Waste Management Facility, 2-4 Hale St, Botany Landscape Concept Design Report

1.0 Response to Council Comments *December 2024*

2.0 Response to Council Comments *May 2025*

Retention of Melaleucas (South-West Corner)

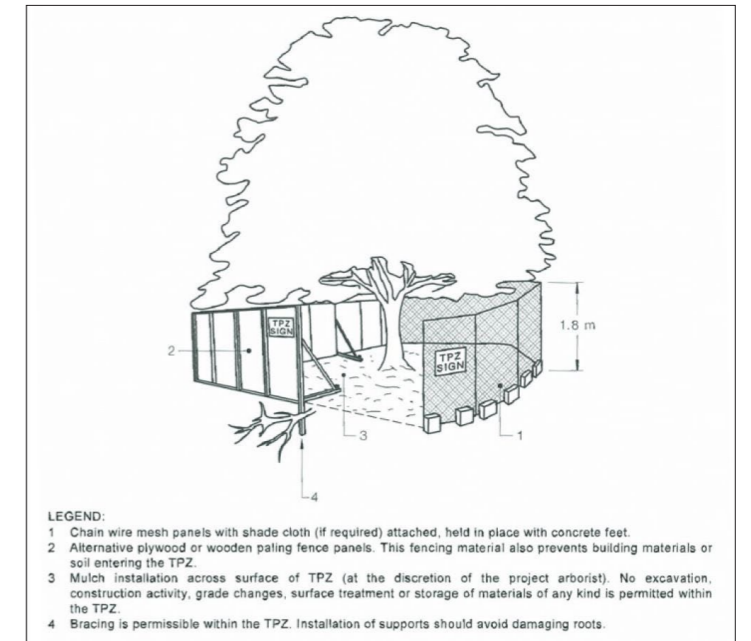
iv. The Landscape Concept Design on page 8 does not address tree retention or removal of trees & vegetation present at the western and south-western site boundaries. Vegetation in this area should be considered in the same way as vegetation on other boundaries of the site.	iv. The updated Landscape Concept Design on page 8 addresses existing vegetation on the western and south-western boundaries, with tree retention and removal consistent with the updated arborist's recommendations. The updated arborist report is attached for reference.	7.0 Demolition Plan. PG 9 8.0 Landscape Plan. PG 10

Two semi-mature *Melaleuca quinquenervia* (Paperbarks) located in the south-western corner of the site are to be retained. The consulting arborist has confirmed that the proposed works will involve minimal ground disturbance in this area, and the development is unlikely to affect the health or stability of these trees.

As a hardy and healthy native species, the Paperbarks are considered highly suitable for retention. Protection measures in line with AS4970-2009 will be implemented during construction to safeguard their ongoing health and ensure they continue to contribute to the landscape character and ecological value of the site.
